**Responses to NRC Questions on WCAP-8859 (Non-Proprietary)  
and WCAP-8860 (Non-Proprietary)**

NS-CE-1694

February 13, 1978

Mr. John F. Stolz, Chief  
Light Water Reactors Branch  
Division of Projects Management  
Office of Nuclear Reactor Regulation  
U.S. Nuclear Regulatory Commission  
Washington, D.C. 20555

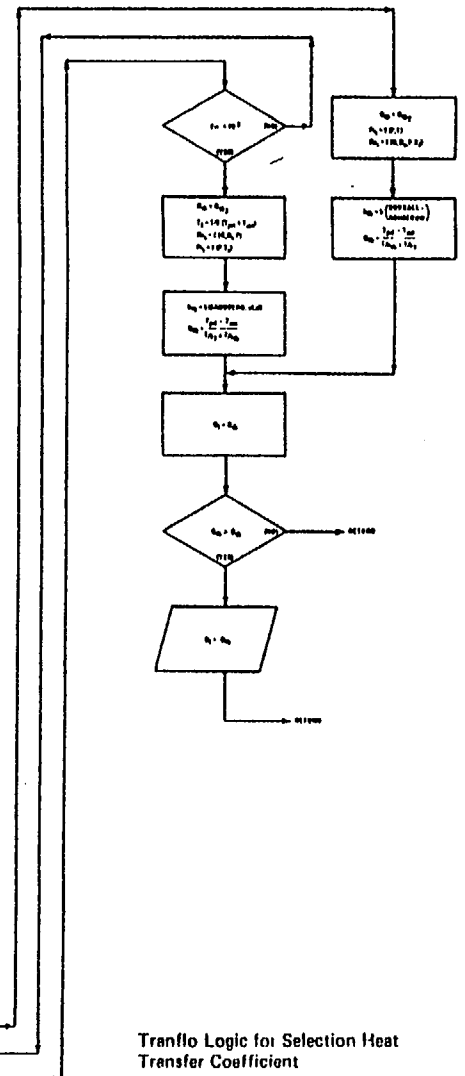
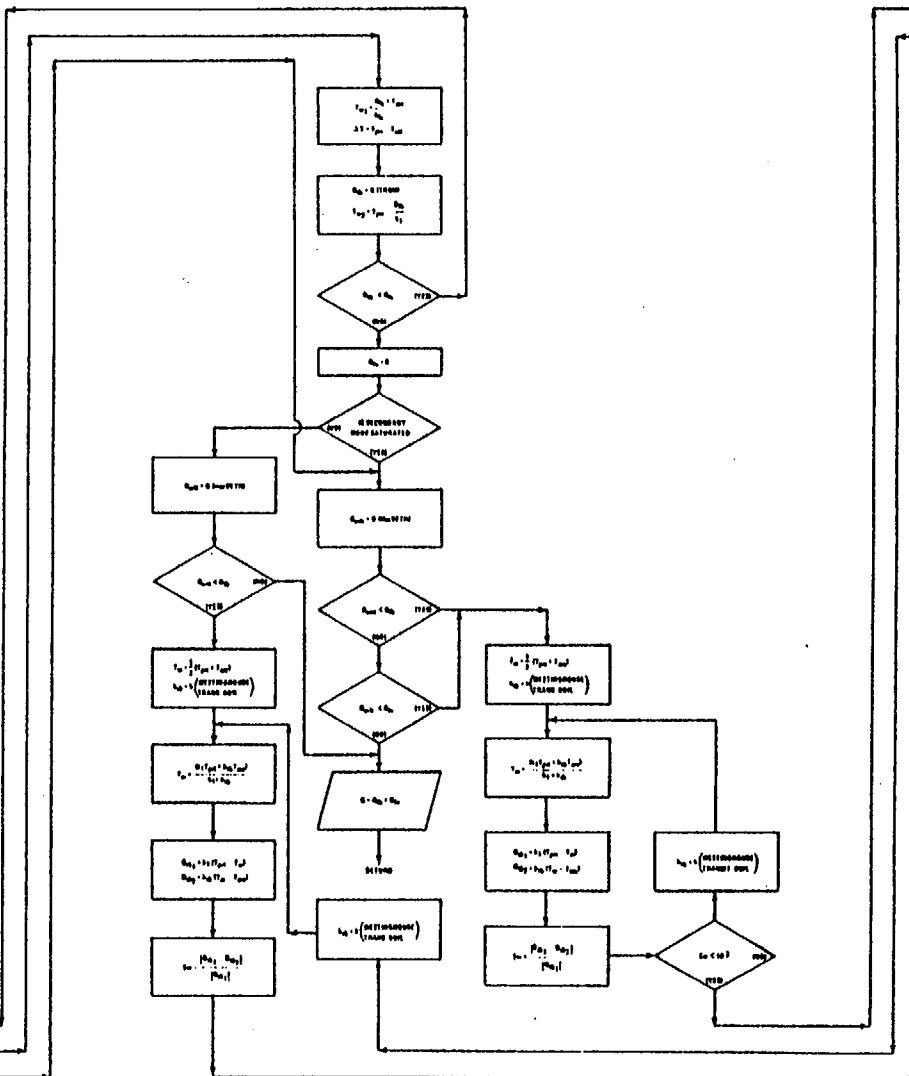
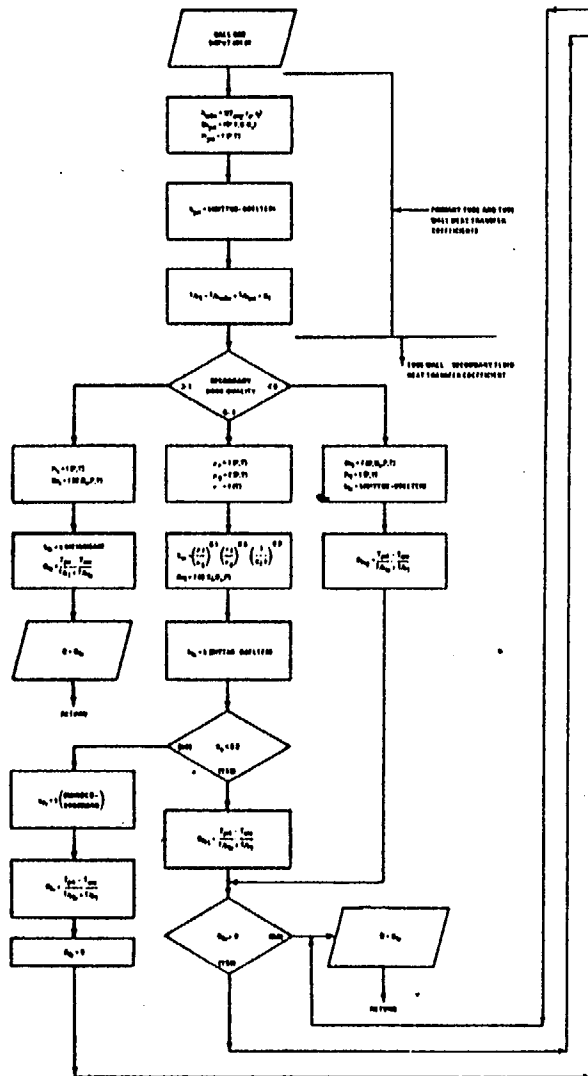
- A. For each correlation listed in Section 3.4 of WCAP-8821, provide justification that heat transfer to the steam generator is conservative for calculation of entrainment.
- B. Provide additional details on the use of each correlation for heat transfer between (1) the primary system and the steam generator tubes and (2) the steam generator tubes and the secondary secondary for both the broken and intact loop steam generators. Provide the criteria for switching between correlations used in the TRANFLO code.
- C. Discuss the form of the Westinghouse transition boiling correlation used in the TRANFLO code. We understand that the correlation exists in a best estimate form and also in a form for ECCS LOCA calculations.

calculations (see Section 3.2.1 of WCAP-8822). For clarification, a logic block diagram of the analysis steps used for determining the releases from the various breaks is attached.

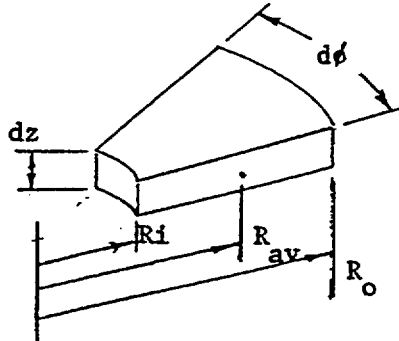
Provide and justify the equations used to calculate the centrifugal force that is used in the swirl vane drain head calculations described on page 4-20. Discuss the assumptions made for flow out of the swirl vanes when the swirl vane drains become filled with water.

A. The centrifugal force head added to the swirl vane drain is

$R_o$  = swirl vane outer radius

$R_i$  = swirl vane hub radius

$W$  = drain flow rate

$\beta$  = swirl vane blade angle

Figure 1  
Slip Factor  
vs.  
Pressure

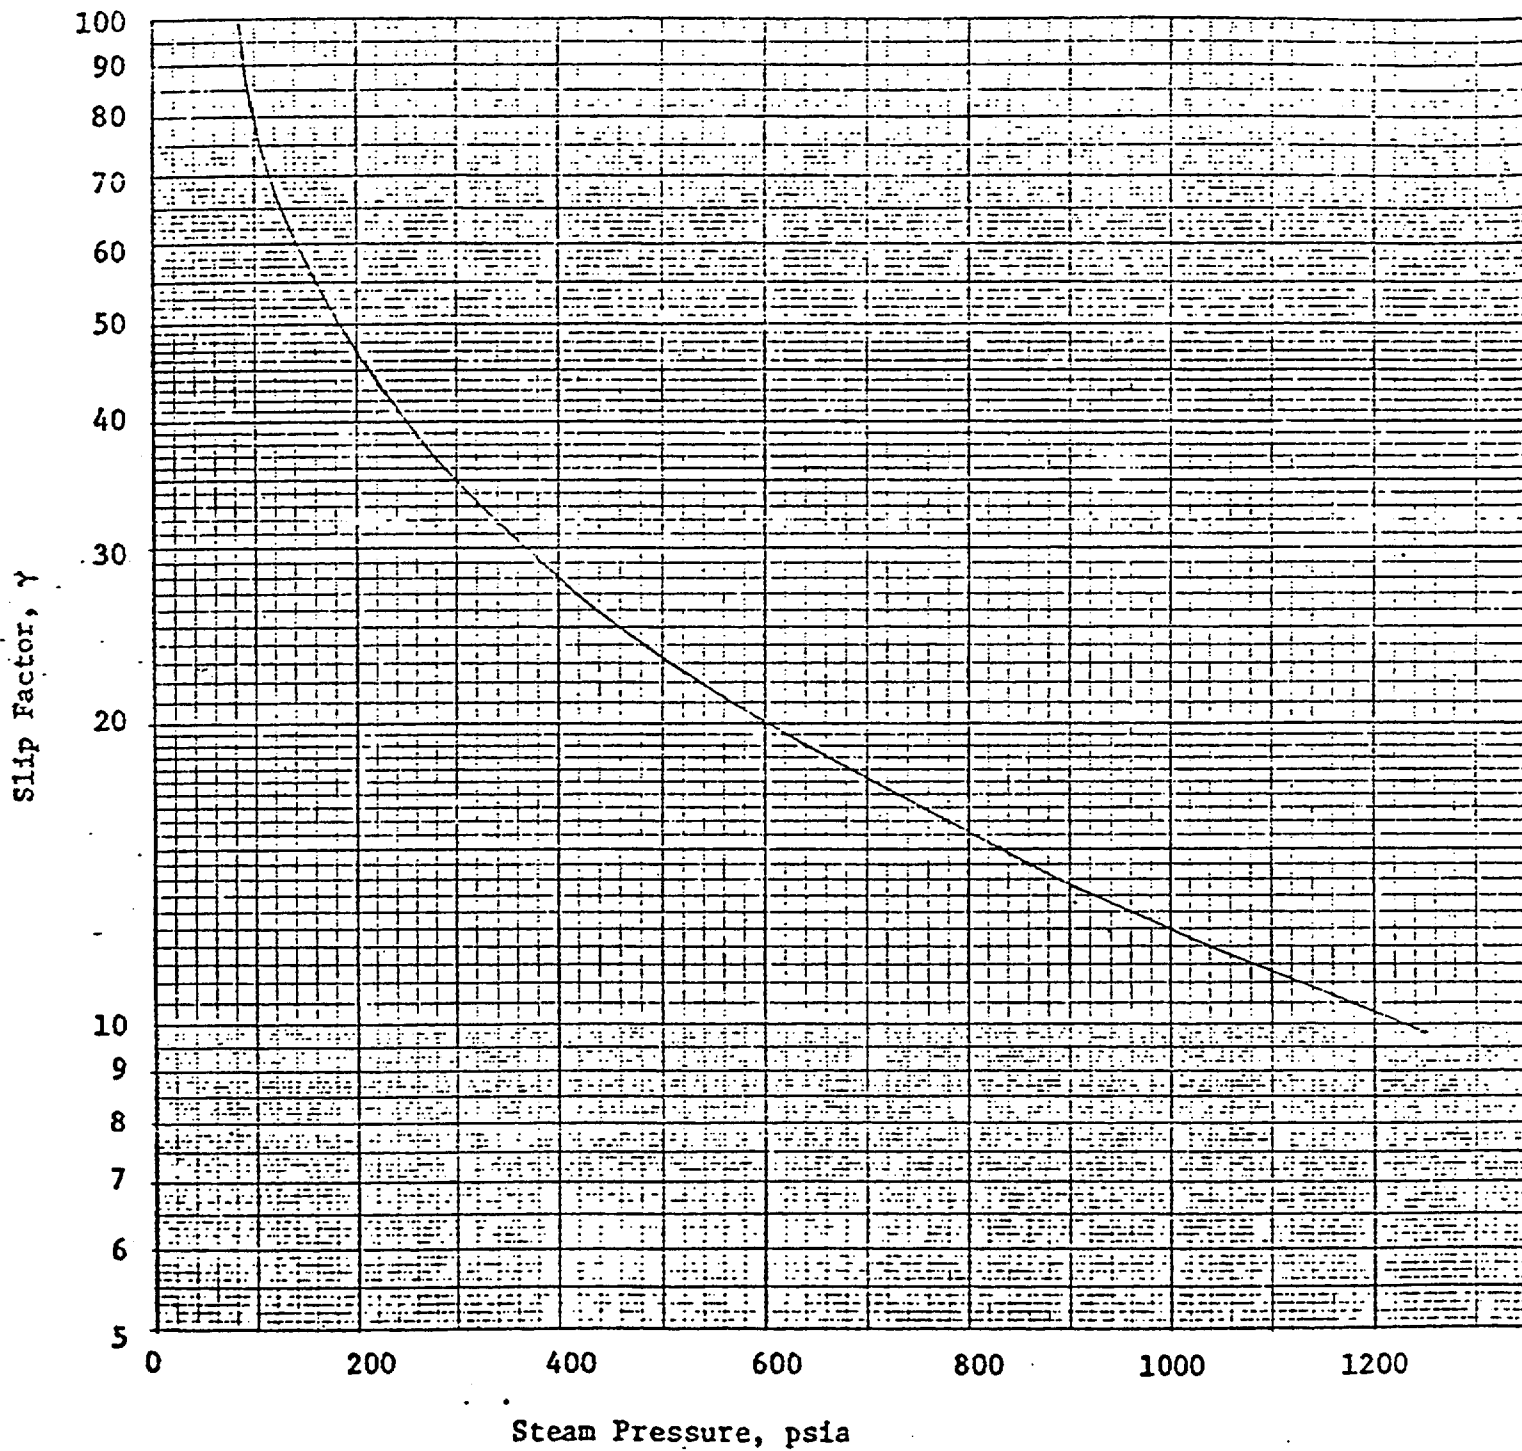
The sensitivity study presented in Figures 5.3.2-1a, b and c indicates that the quality leaving the break is relatively insensitive to assumed values of swirl vane separation efficiency. These results do not appear to be consistent with the comparisons presented in Figures 5.3.2-6, 7 and 8, which exhibit a large sensitivity to swirl vane efficiency predicted by the Steady State Experimental Model. Discuss the reasons for this apparent inconsistency. Provide the empirical correlations discussed on page 5-46 used to generate the comparison with the computer model and discuss the differences between these correlations and the TRANFLO correlation presented on page 4-20. Discuss which empirical correlation was used for each comparison.

This curve is plotted on Figure 1.
